Report on a Publicly Notified Resource Consent Application

(Section 42A)

Application Reference:	RMA/2025/2613
Applicant:	Wenborn Developments Ltd
Site address:	2 Gosset Street and 25 Westminster Street, St. Albans
Legal Description:	Lot 43 DP 6614
Proposal:	Demolition of a defining building within a Residential Heritage Area and the construction of two residential units with associated landscaping and earthworks
Zoning:	Medium Density Residential
Overlays and map notations:	Liquefaction Management Area Character Area Overlay – Malvern (CA11) Residential Suburban Density Transition Overlay Urban Intensification Area Defining building within Residential Heritage Area – Church Property Trustees North St. Albans Subdivision (1923) (HA3) Street Trees (Unique IDs 40930 and 40931)
Activity status:	Restricted Discretionary
Submissions:	4 in support 27 in opposition (11 of these submitters seek to be heard) (see Appendix 1)
Date of Hearing:	8 June 2026
Recommendation:	Refuse the application

Figure 6: Westminster Street's development pattern

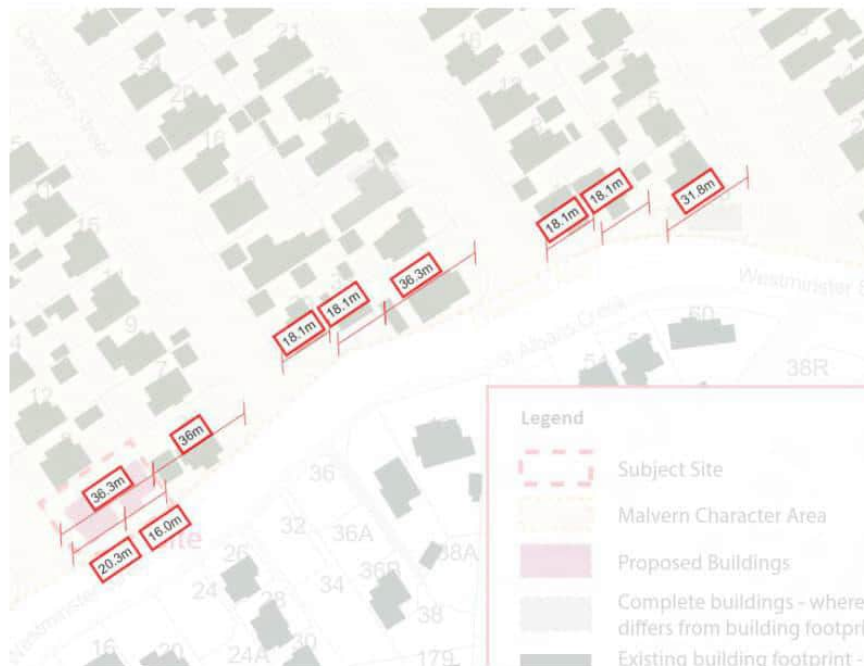
11. Unlike these existing character sites which generally have deeper site lengths, the proposal re-oriens development to use the original site width as depth. This results in a reduction in garden area, and reduces the separation and space for planting between buildings in this part of the character area. However, overall, in relation to this matter, I consider that the proposal adequately replicates the existing pattern, character of Gosset Street and the visual coherence of the area, but I have reservations about the proposed separation distance between the proposed buildings which I discuss further in the following matters under *Site character*.
